**NUCLEAR REGULATORY COMMISSION**

ADVISORY COMMITTEE ON REACTOR SAFEGUARDS

WORKING GROUP NO. 4

Date - Thursday, 25 March 1976

ASYMMETRIC INTERNAL PRESSURE LOADING ON RPV DUE TO COLD LEG BREAK

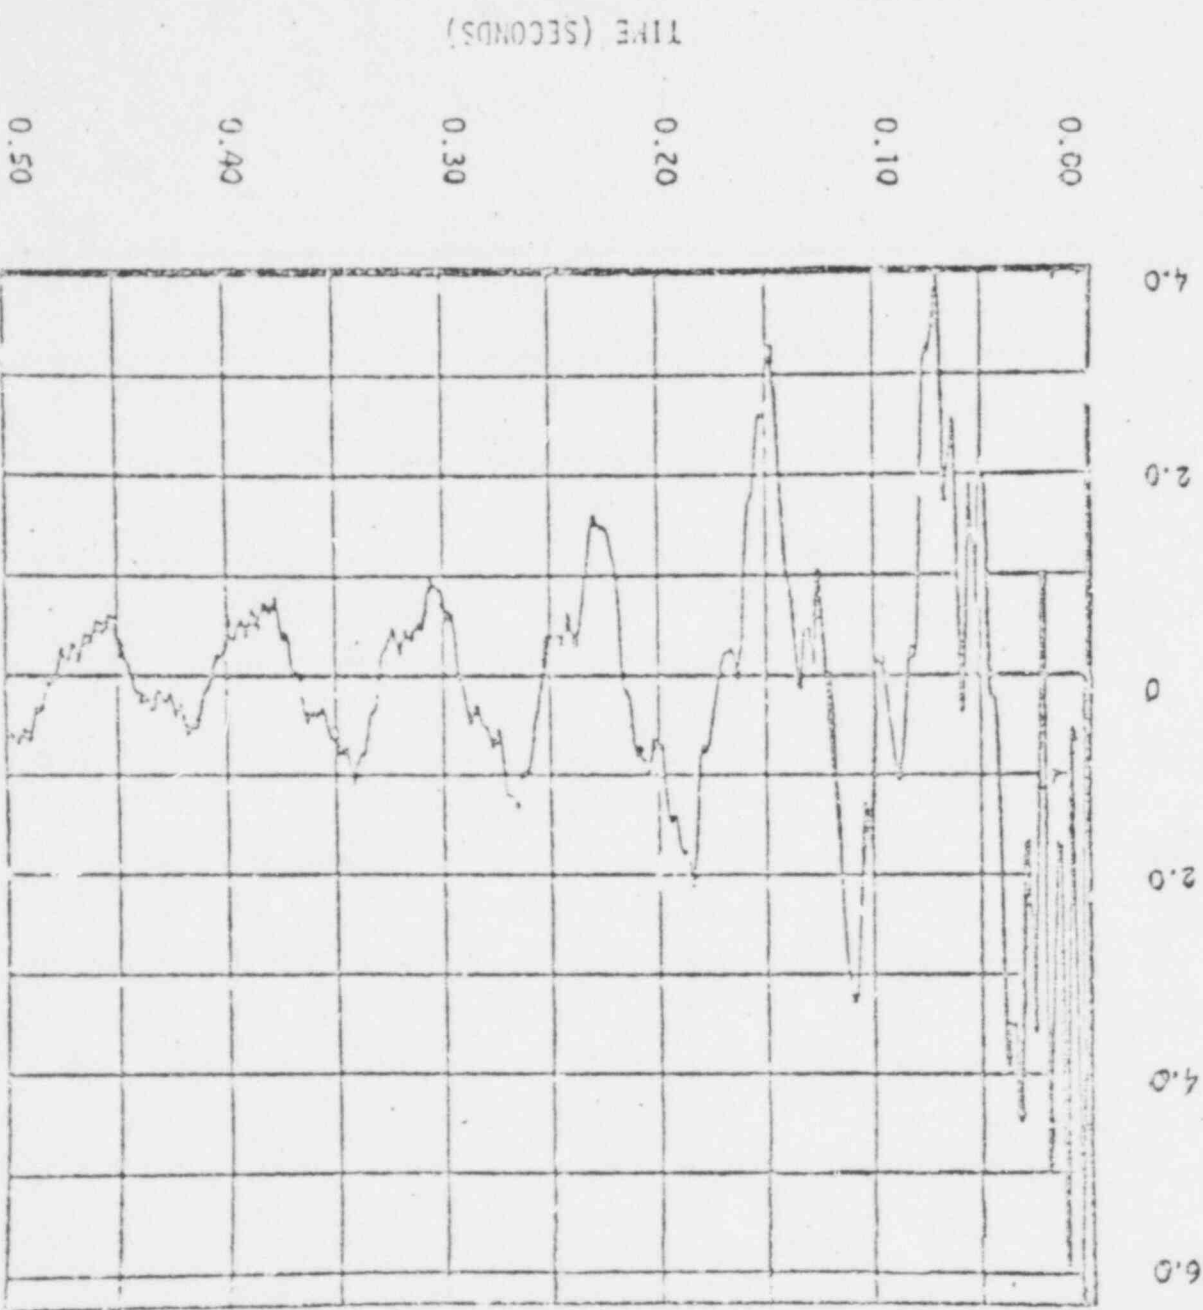
"FROM PAST EXPERIENCE WITH PRIMARY PIPING SYSTEMS, CRACKS ARE MOST LIKELY TO OCCUR AT THE VESSEL SAFE END (POINT A ON FIGURE 1). THIS IS THE MOST SUSCEPTIBLE POINT FOR AN INSTANTANEOUS PIPELINE BREAK. FAILURE COULD CAUSE AN INSTANTANEOUS PRESSURE WAVE TO BUILD UP BETWEEN THE INSIDE OF THE BIOLOGICAL SHIELD AND THE OUTSIDE OF THE REACTOR PRESSURE VESSEL. THIS INSTANTANEOUS PRESSURE WAVE COULD BE HIGH ENOUGH TO CAUSE THE VESSEL TO MOVE SIDEWAYS, OR TO TIP OVER AGAINST THE FOUNDATION CAUSING SEVERE AND UNKNOWN DAMAGE.

DESPITE THE LOW PROBABILITY OF OCCURRENCE PROTECTION AGAINST EFFECTS OF PIPE RUPTURE POSTULATED TO OCCUR AT THE NOZZLE SAFE ENDS HAS BEEN A DESIGN REQUIREMENT FOR ALL LMR'S FOR MANY YEARS.

IN ADDITION TO "INSTANTANEOUS PRESSURE WAVES" EFFECTS OF SYSTEM REACTION FORCES AND TRANSIENT INTERNAL FORCES MUST ALSO BE EVALUATED.

JUSTIFICATION FOR  
BAFFLE REMOVAL

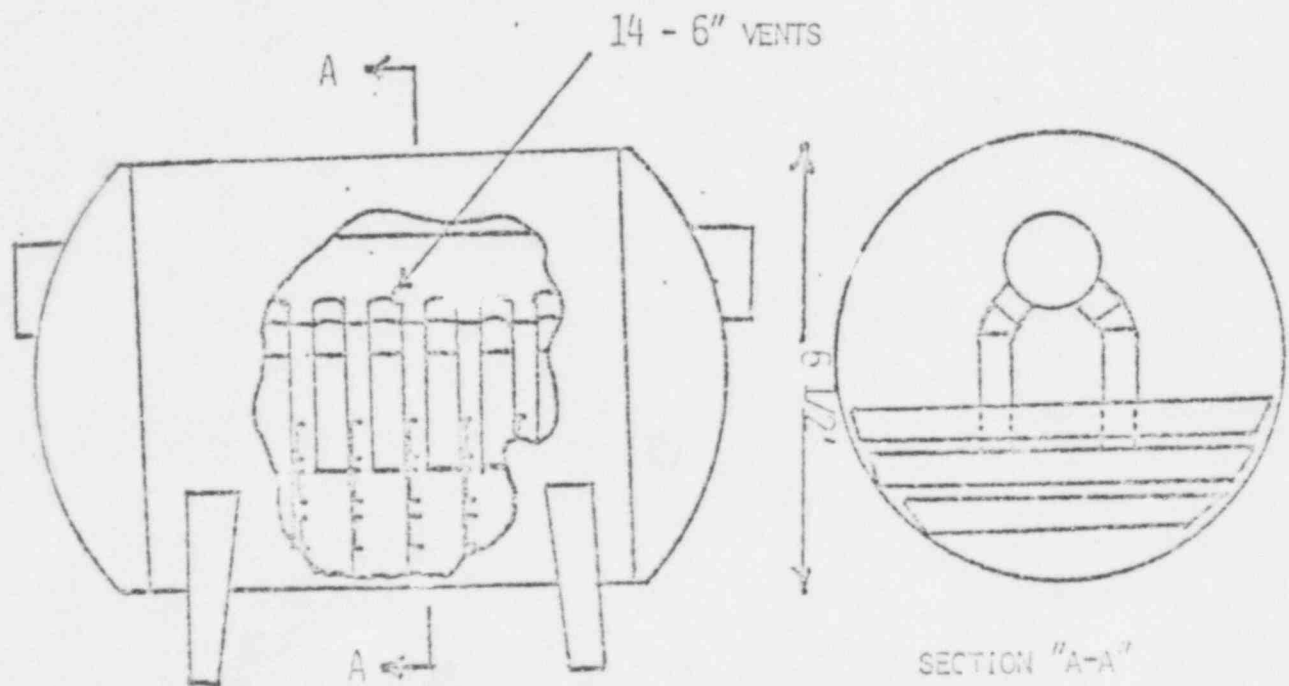
TESTS AND ANALYSES SHOW THAT REMOVAL OF BAFFLES WILL NOT RESULT IN AN INCREASE IN THE WETWELL PRESSURE ABOVE THE PLAK PRESSURE DETERMINED BY AIR TRANSFER FROM DRY: ILL TO WETWELL

ACCELERATION OF PRESSURE VESSEL PEDESTAL  
SUMMARY OF DETAILED DISCUSSION

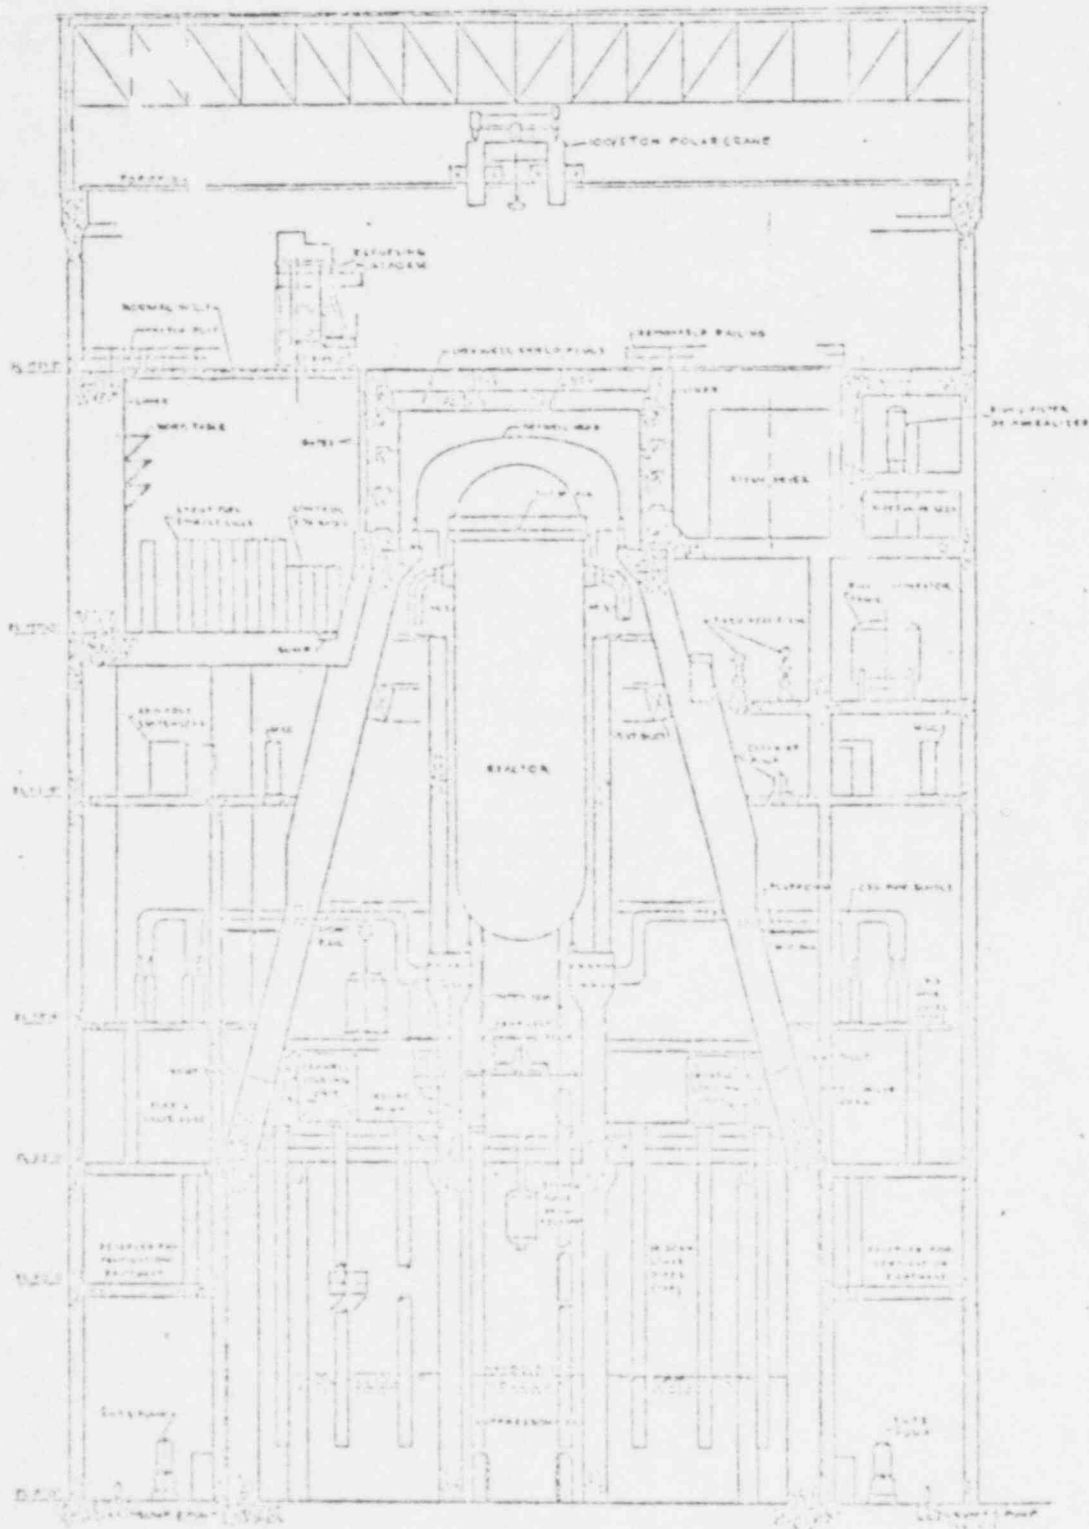
"Another serious problem in "pressure suppression" plants is the possibility of vessel pedestal acceleration resulting from the loads on the pedestal created by the pressure wave developed in the suppression pool (see Figures 4 and 5). These loads on the structure may be transmitted through the soil and through the foundation causing the vessel support pedestal to vibrate to a degree greatly above the seismic design basis for the equipment. This condition could result in failure of the vessel and internals, failure of the core support structure, possible loss of emergency core cooling capabilities, possible loss of insertion capability of the control rods, and, again, untold effects by the accident that could occur. This condition should be thoroughly reviewed by the NRC."

The February 18, 1976 testimony alleges that the reactor vessel support pedestal could be caused to vibrate (be accelerated) by loads originating in the pressure suppression pool if a design basis pipe rupture were to occur.
